PLANNING COMMISSION MEETING

CITY OF MADRAS
Request for Planning Commission Action

Date Submitted: November 29, 2023
Agenda Date Requested: December 6, 2023
To: Madras Planning Commission
From: Fatima Taha, Associate Planner
Files: CU-23-2, SP-23-4, & SD-23-5
Subject: Conditional Use, Site Plan, and Subdivision Replat Application for Starbucks

PLANNING COMMISSION FINDINGS AND DECISION

JOB NO. 21-263
 DRAWN BY: MW/JJW
 DRAWING: P1.0

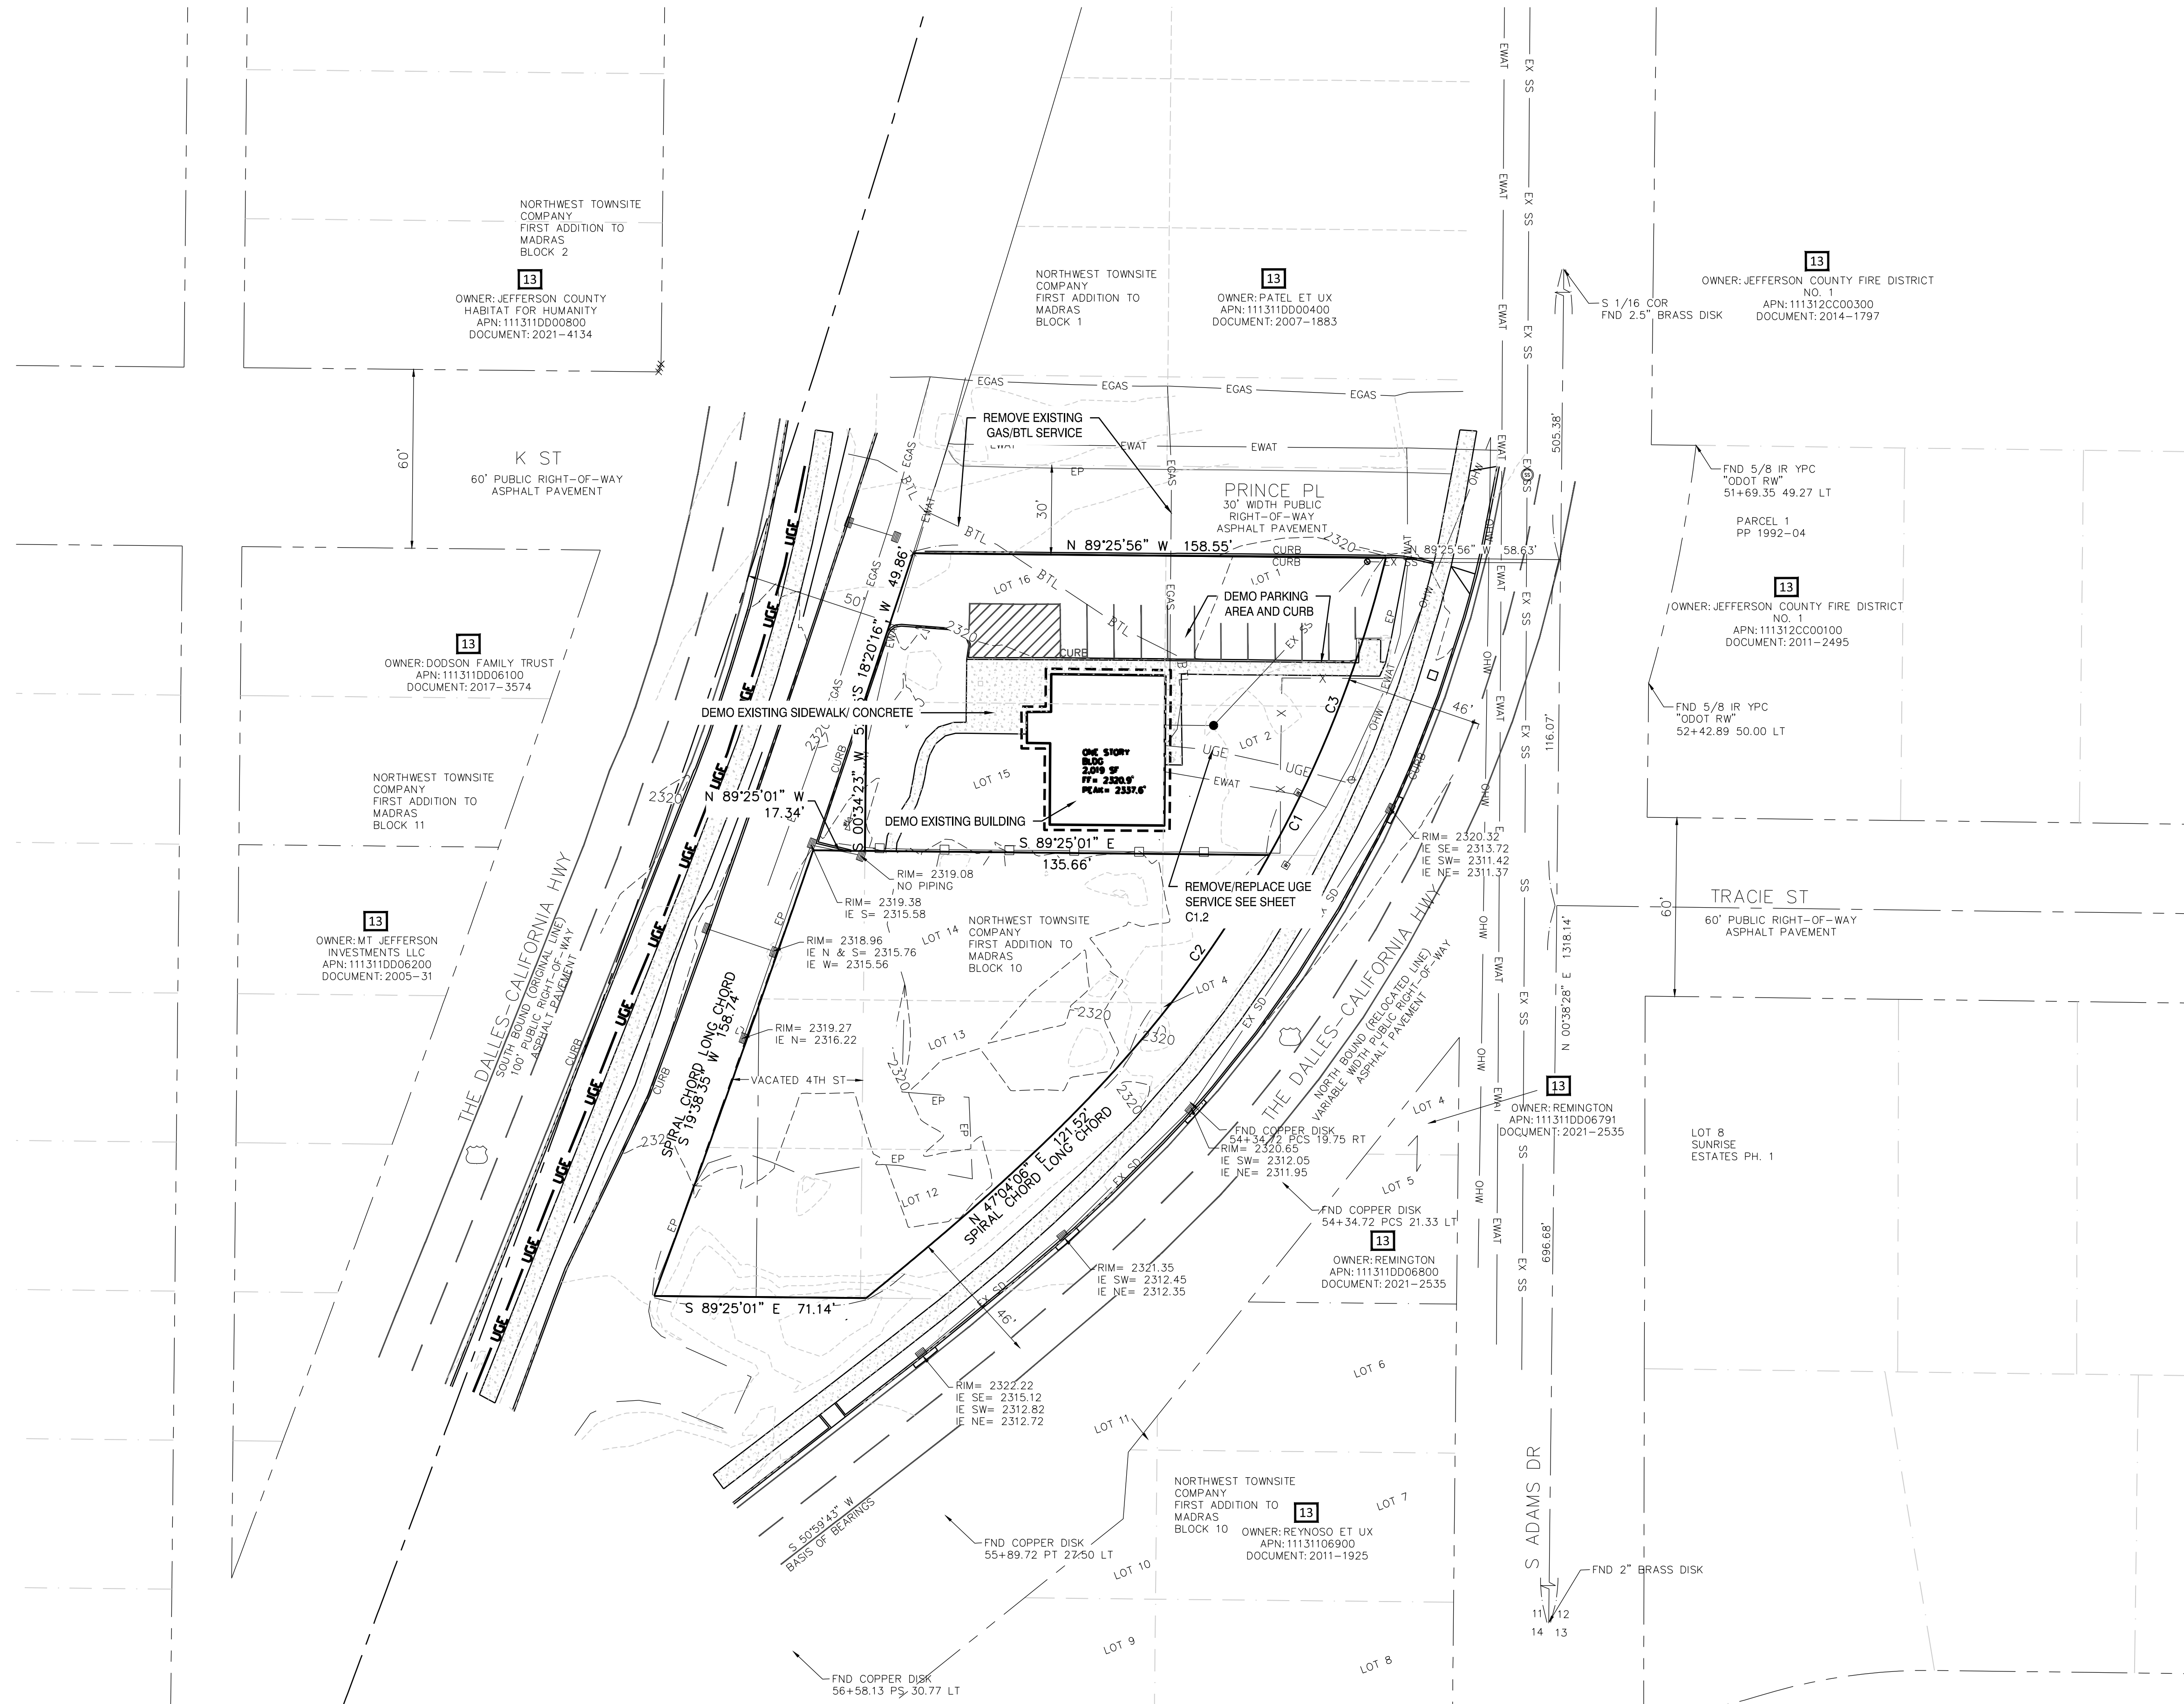
FINDING: The materials submitted by the applicant (Sheet P1.0) identifies no new proposed streets will be developed. This standard is met.

FINDING: Per materials submitted by applicant, the proposed use is an Eating and Drinking Establishment (i.e., Starbucks) with a drive through. The proposed drive through stacking lane in the site plan (Sheet P1.0 & P1.2) is a single stacking lane and separated from the property line by a minimum of 5 feet setback. Based on the applicant's ability to comply with the requirements of MDC 18.30.160, the above stated standard is satisfied.

LANDSCAPE REQUIREMENTS
 TOTAL LOT AREA: 33,528 SF
 REQUIRED LANDSCAPE: 3,353 SF [10%]
 PROVIDED LANDSCAPE: 12,740 SF [38%]

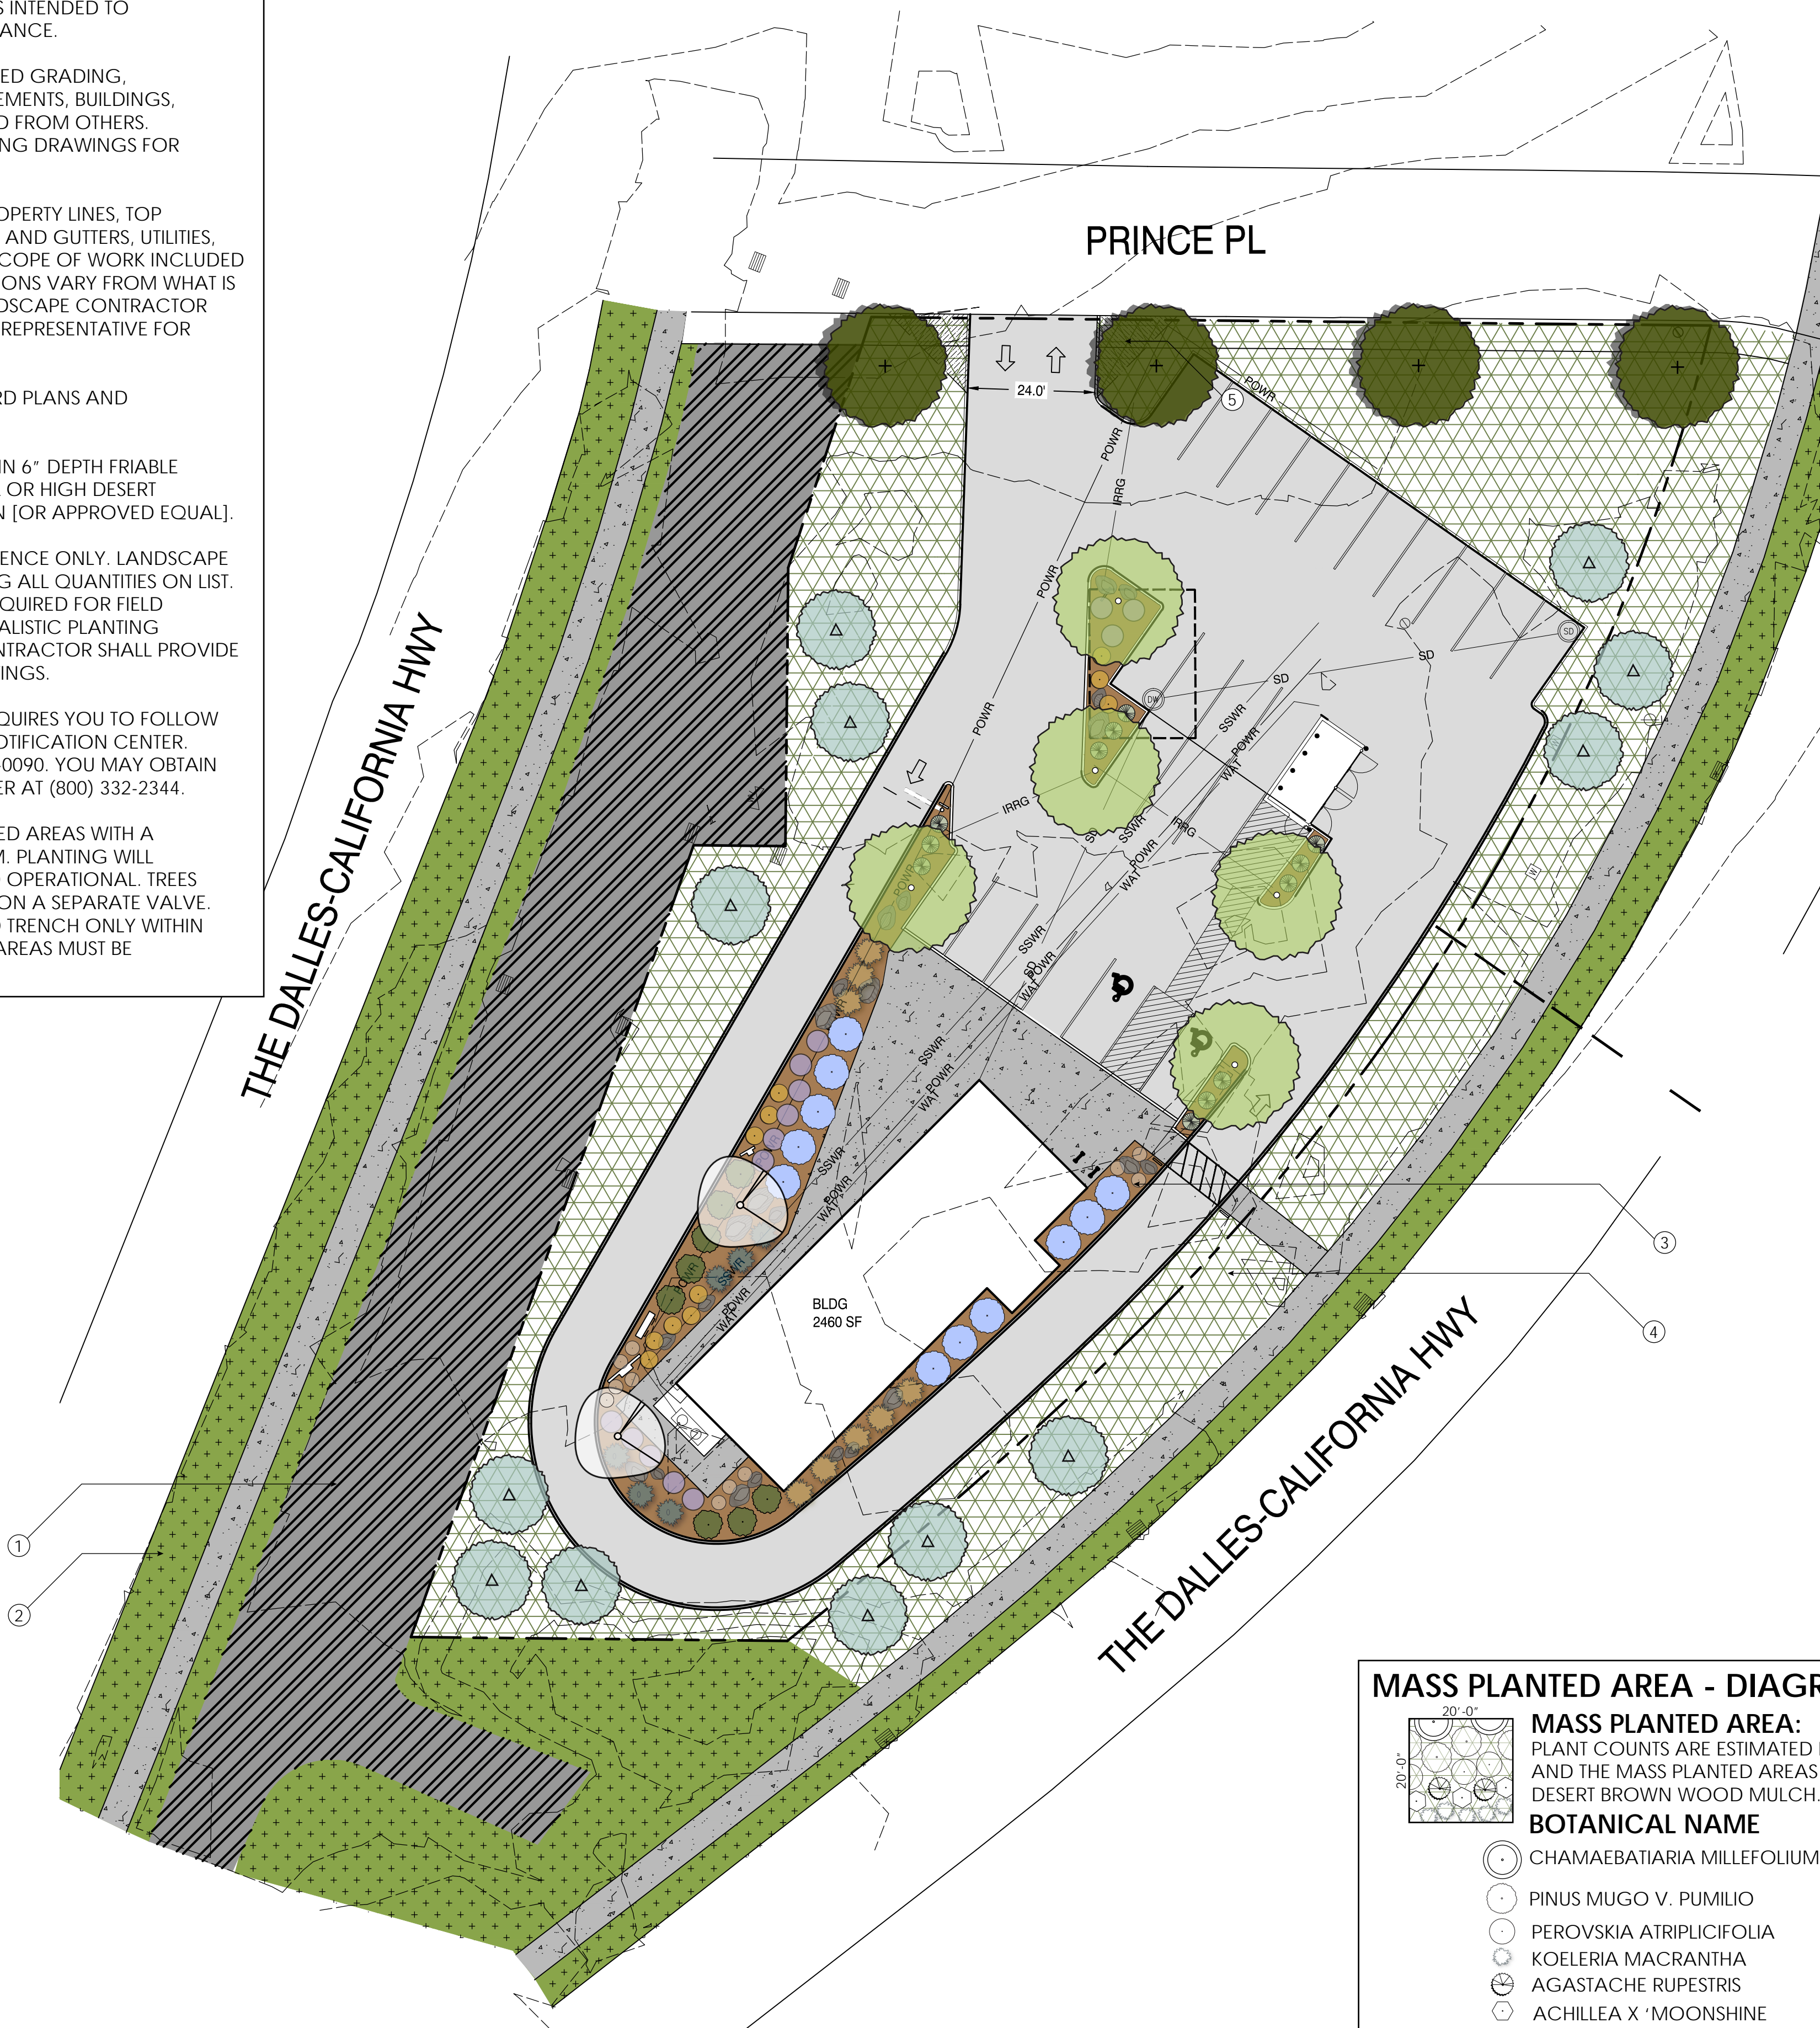
FINDING: The applicant has submitted a landscaping plan (Sheet L1.0 & L1.1) for proposed development on the lots within the proposed subdivision replat. The proposed landscaping is 38% thus exceeding the minimum amount of landscaping in the community commercial zone. The proposed parking area is 9,921 square feet and a total of 28% of landscaping has been proposed within the parking lot and the area surrounding the parking area. The proposed landscape exceeds the requirement of 15% on public gathering areas in planter beds. The standards stated above are met.
